TECHNICAL BULLETIN INDEX
Sorted by Bulletin Number
06/25/86

DATE: May 12, 1982
REVISION DATE: May 13, 1983
BULLETIN NO: 16:1
PRODUCT: 26-6001/2 Model 16
SUBASSEMBLY: AX-9241 FDC Board (Redesign)

FIG 1

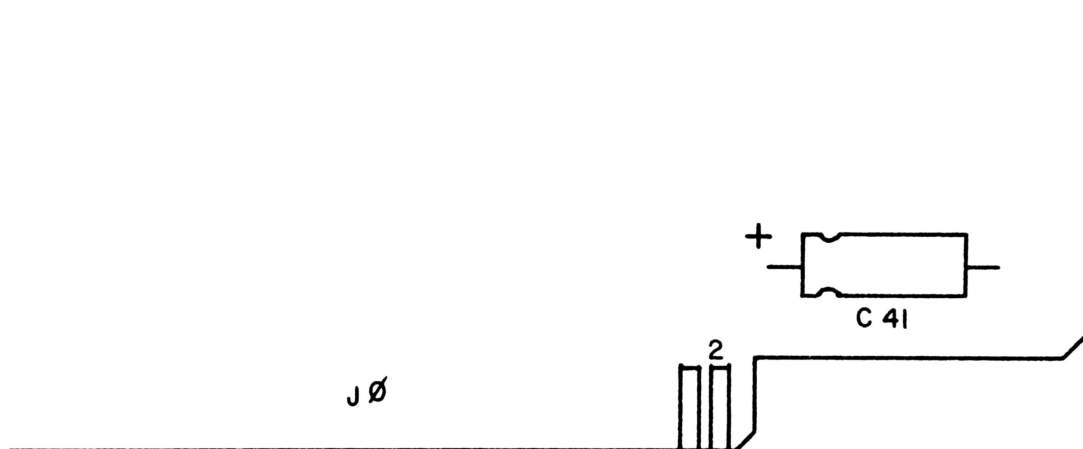
PURPOSE: To correct problem of C41 being installed backwards on early revision D Z-80 CPU boards.

DISCUSSION: On early Rev D boards C41 was installed backwards. This board and earlier revisions have had the (+) sign silk screened onto the board at the wrong end of the cap. The heavy trace attached to the capacitor on the component side of the PCB is ground and the positive lead of the cap should go to the other hole on the PCB.

PROCEDURE: Check all computers that are brought into the shop for this capacitor. If it is reversed, replace it with a new 33 mfd. cap with a voltage rating between 16 and 50 volts (Refer to Figure 1 for correct installation).

FIG 1

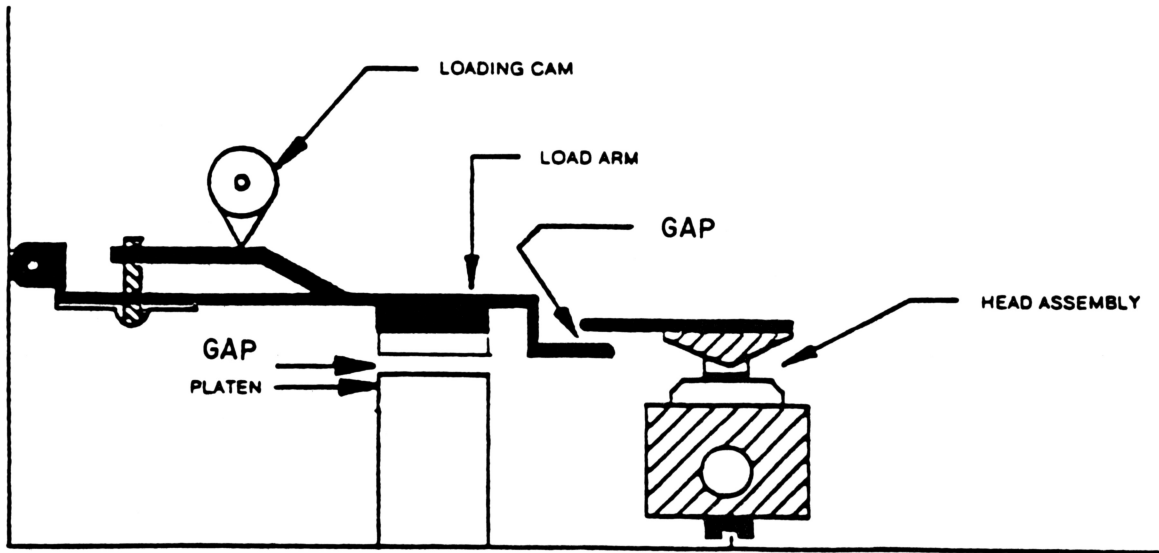
DISCUSSION: On some thinline drives the foam pad under the head load arm has been misadjusted so that the foam pad applies too much pressure to the diskette not allowing it to turn as it should. This problem can be solved by adjusting the head load arm. Also, on some drives the disk ejector has been pressing against the arm that presses the cone into the diskette. When this happens the diskette is not held as tightly as it should be. To correct this problem the trigger for the disk ejector can be adjusted.

The head load arm should be adjusted so that there is about a .015-.030 inch gap between the foam pad and the platen (Refer to Figure 1) with the door closed and no diskette installed. Once this has been adjusted there should be a visible gap between the foam pad and the platen with the door closed and no diskette installed. Check that the upper head does not rub against the head load arm with a diskette installed and that the upper head does not hit the diskette when the diskette is being inserted or removed.

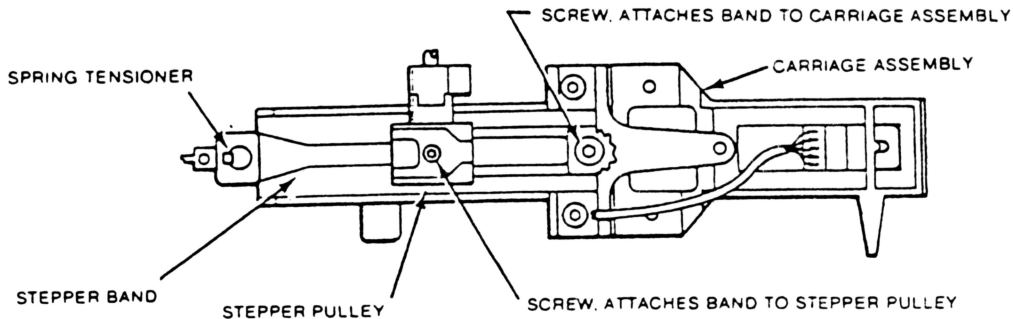
When two collectors from the group of transistors Q1-Q4 short together, the motor will not run or run slowly. It also causes Q2Ø to draw excessive current to compensate for the loss of the affected transistors and blow one of the 24 volt fuses. The same applies when Q2 or Q4 shorts to the bracket under Q2Ø.

If Q2Ø shorts to the bracket, the speed control circuit will be bypassed and the motor will run at its top speed. This occurs only if the bracket is grounded (mounted in the Model 16), so the problem may not occur if the drives are removed from the computer.

When servicing the drive, make sure that the heat sink tabs (collectors) of transistors Q1-Q4 do not touch each other or the heat sink/mounting bracket under Q2Ø. Also, check that the heat sink tab of Q2Ø does not short through the insulator to the bracket it is mounted on.

Figure 1.

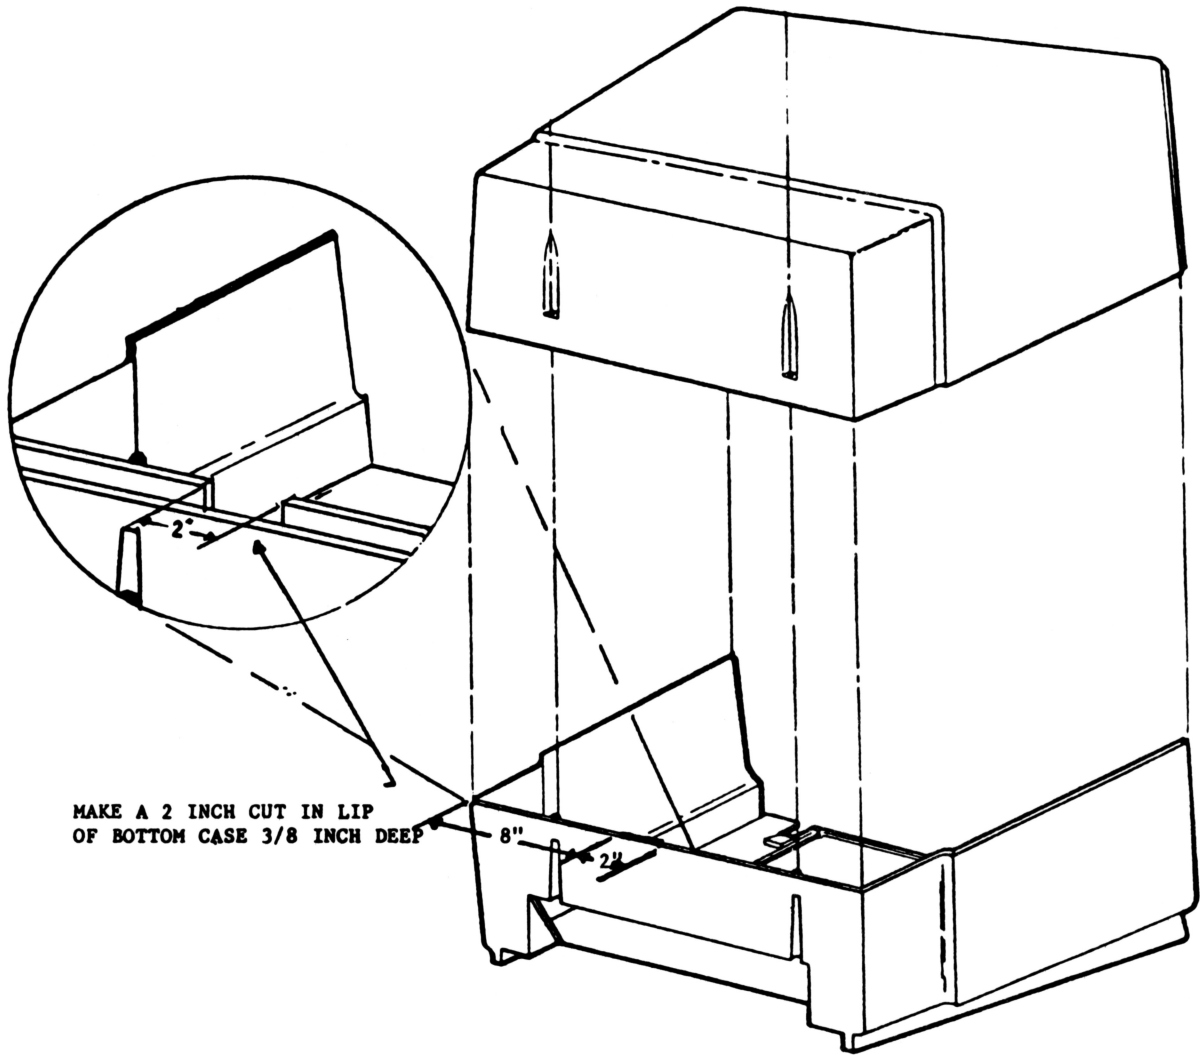
DISCUSSION: To install Multi-terminal Interface in the Model 16 you will have to modify the case bottom to allow external connection of the cables. Install the Multi-terminal Interface board in the #4 slot of the card cage so that the board will not interfere with any other boards or cables. If there is any other board in this slot move it to next available slot.

1. Remove case top to allow access to the case bottom.
2. (Refer to figure 1.) Measure 8" inches from left side (drive side) make a 3/8" inch deep cut, then measure 2" inches from first cut, and make another 3/8" inch deep cut. Cut away the two inches of plastic between the cuts. Clean the notch and make it smooth as possible.
3. Install Multi-terminal Interface board in #4 slot of card cage (**count from the Z-80 CPU board to the left.**) The proper slot positions should be filled as follows: (1) Z-80 CPU Board (2) FDC Board (3) Hard Drive Interface Board (4) Multi-terminal Interface Board (5) Video Board (6) 64K Memory Board (7) 68000 CPU Board (8) 16-Bit Memory Board, reading from right to left as you are facing the rear of unit looking at the card cage. If there is a board in #4 slot move all boards to the left leaving the #4 slot open for the multi-terminal board.

4. Fasten the extender cables to each port with the screws provided with each cable, to insure the cables do not become disconnected from inside the unit. Place the cables neatly on top of each other in the notch made in step 2.

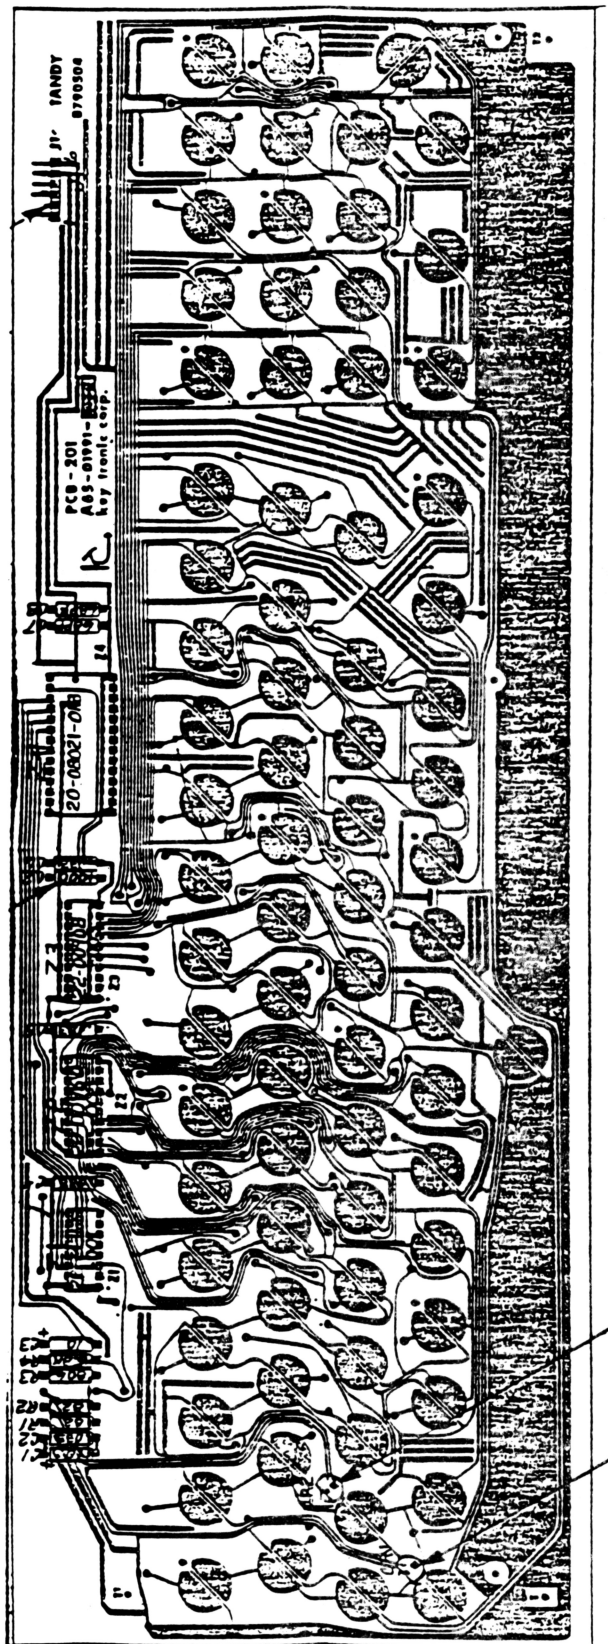
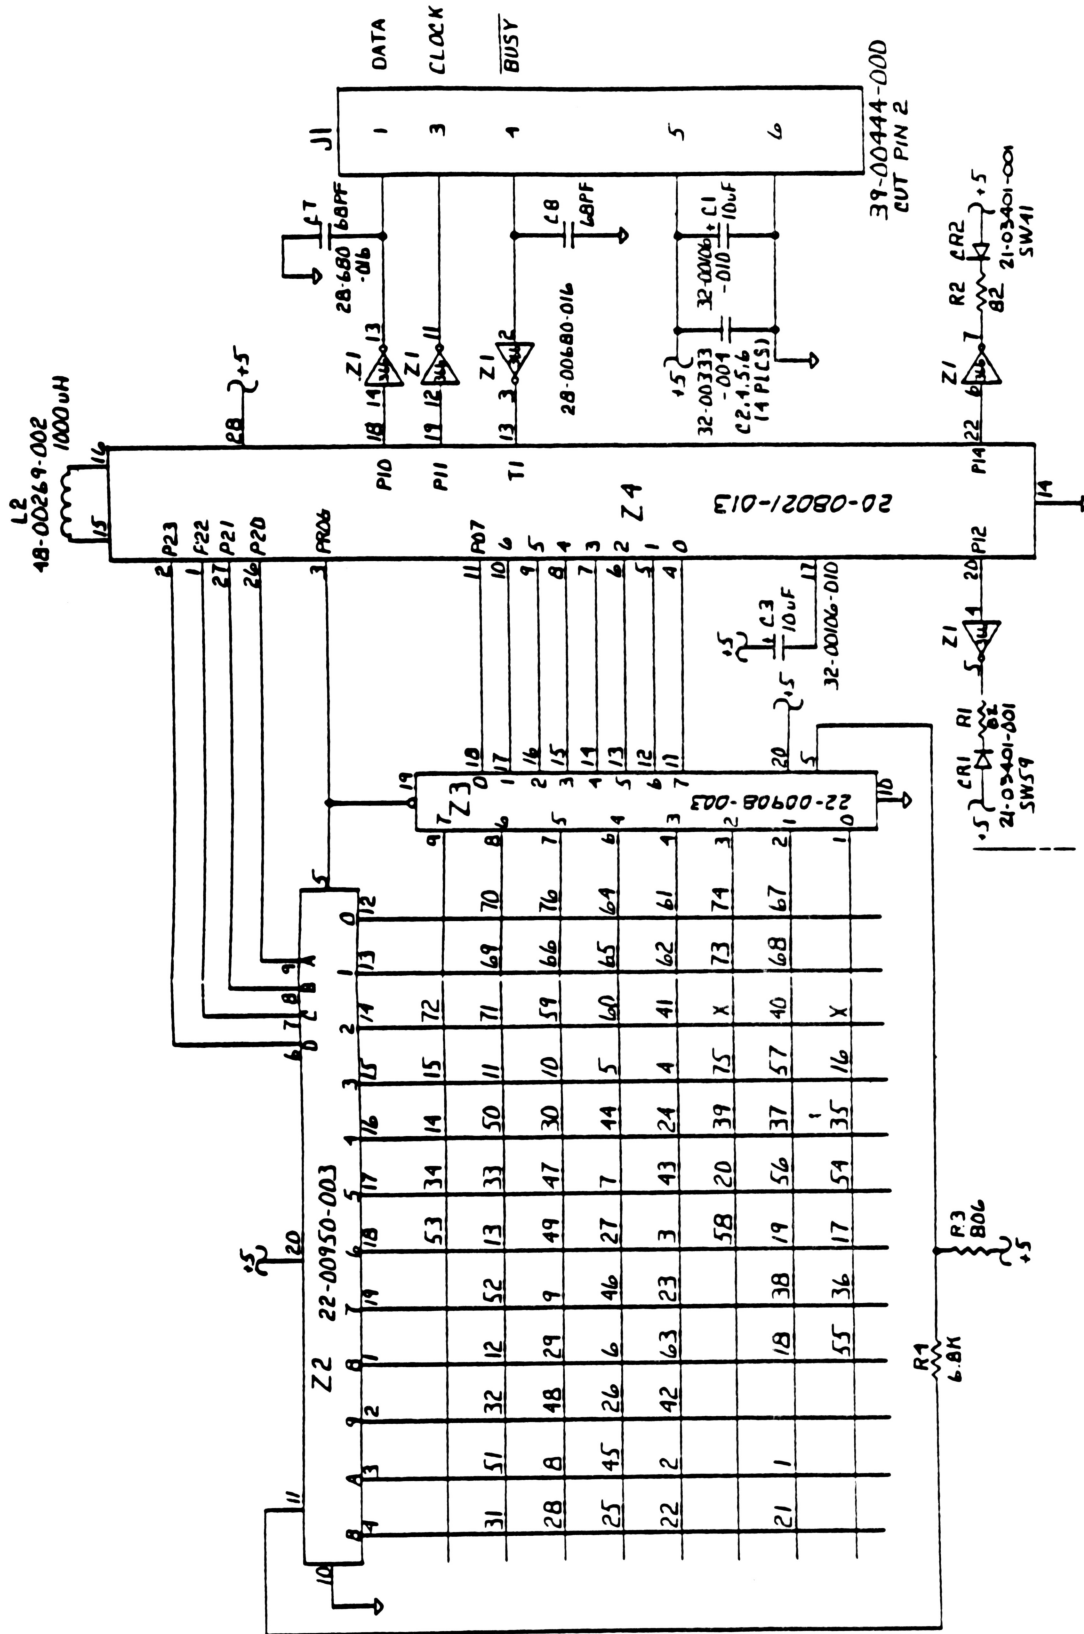
PURPOSE: Correct, and clarify the schematics on the model II/16 Key Tronic keyboards.

DISCUSSION: The Schematics for the Model II/16 keyboards in the Model II Technical Reference Manual are incorrect. Attached is the correct schematic and component location diagram.

SOLDER SIDE (LAYER 4)

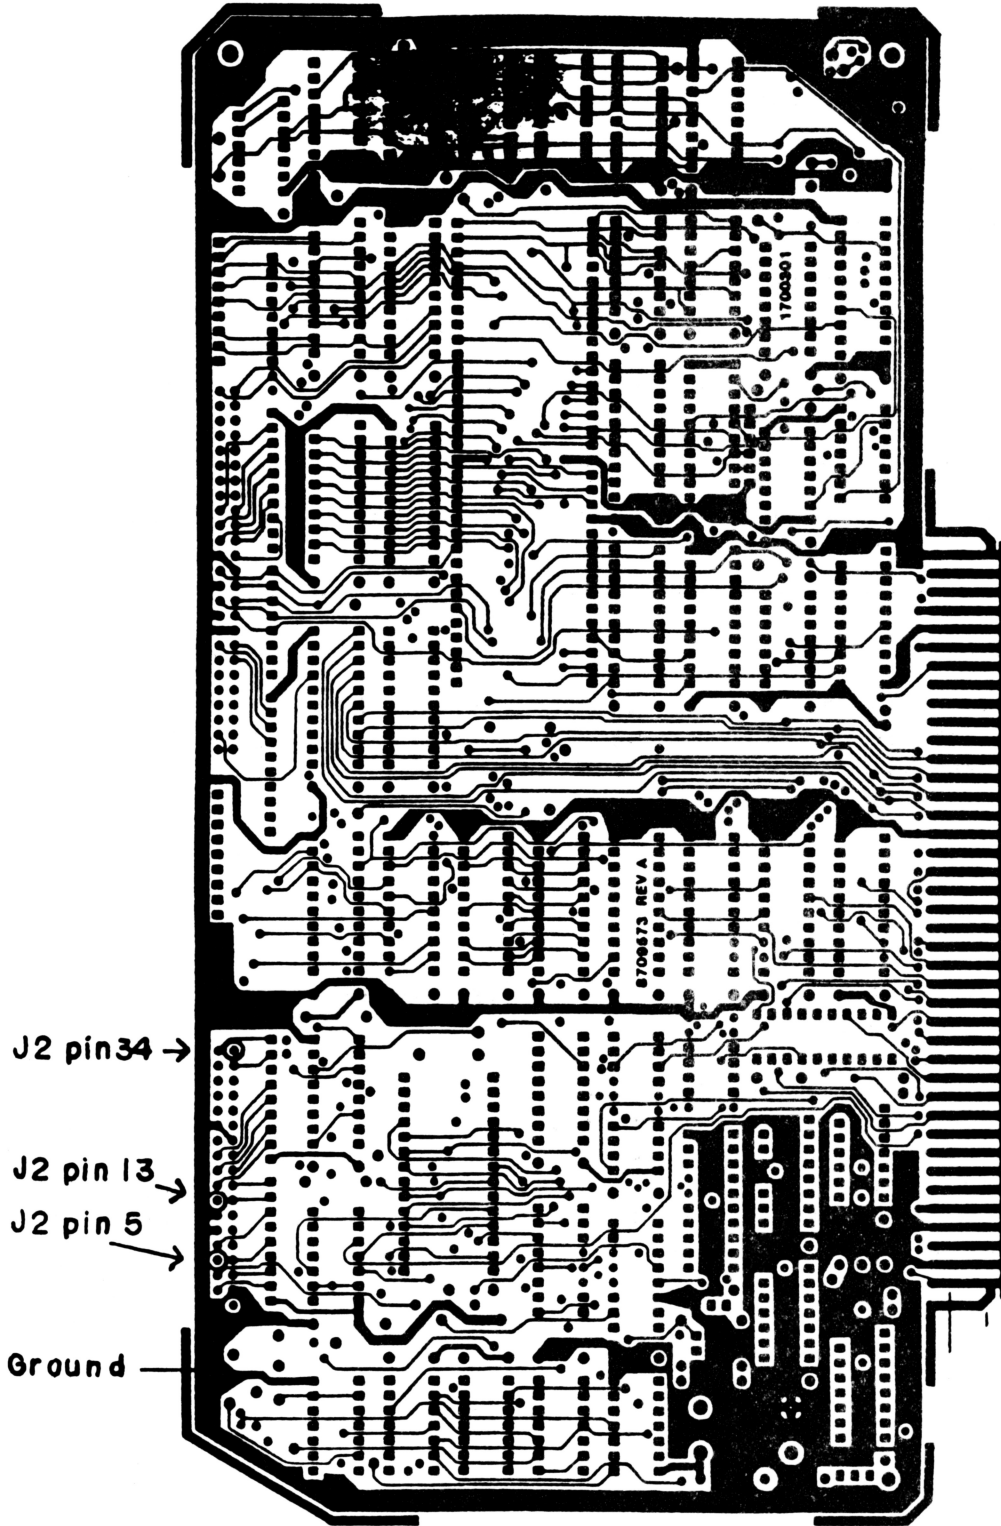
Due to an error in the artwork on early revision (Revision A) boards, a modification to insure good ground connections between the 68000 CPU board and associated memory boards is required.

Using wire wrap wire, install the following jumpers on the solder side of the 68000 CPU board:

- (1) Jumper J2, pin 5 to ground.
- (2) Jumper J2, pin 13 to ground.
- (3) Jumper J2, pin 34 to ground.

Ground may be found at the feed-throughs on the ground plane near J2 on the solder side on the board.

Figure 1.

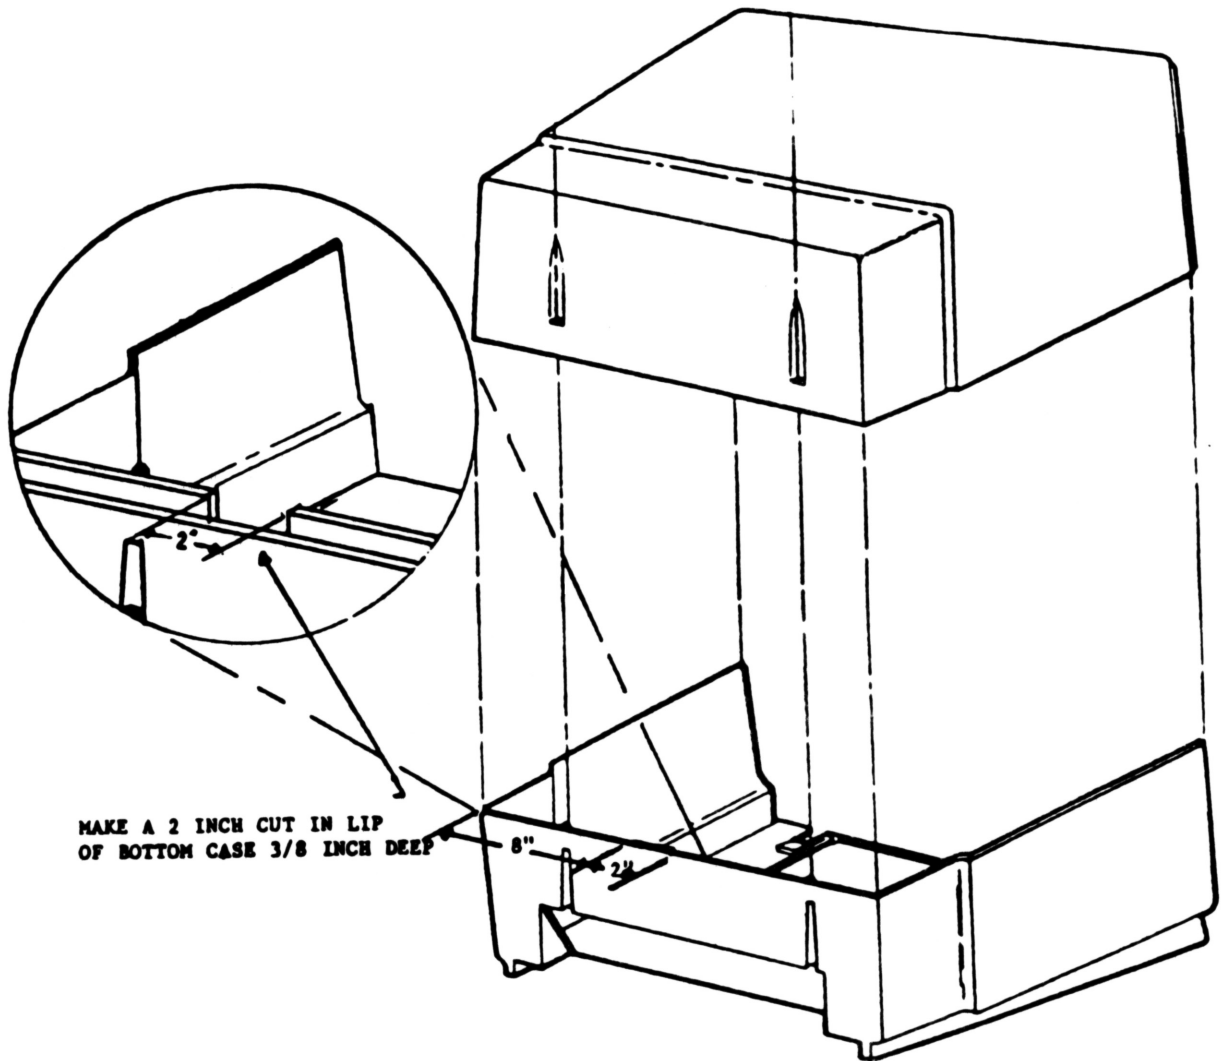
The mechanical alterations involve modifying the lower portion of the case to provide an exit for the Disk Cartridge System (DCS) interface cable, and adding a bracket to the card cage which allows the card cage retaining bracket to be used in a position which will not conflict with the cable connector on the DCS Interface board.

- (1) Remove the case top to allow access to the case bottom.
- (2) Refer to Figure 1. Measure eight (8) inches from the drive side (left side as viewed from the back) of the machine. Make a 3/8" deep cut. Measure two (2) inches further to the right from this first cut, and make another 3/8" deep cut. Cut away the two inches of plastic between the cuts. Clean the notch and remove all burrs.
- (3) Install the DCS interface board in the fourth card cage slot (viewed from the back, start with the **Z80 CPU board and count towards the left**). The extender bracket (Figure 2) will be installed as shown in Figure 3, on the side of the card cage nearest the floppy drive. The card cage bolt will pass through the hole in this additional bracket, and the end of the card cage retaining bracket will be held by the extender bracket.
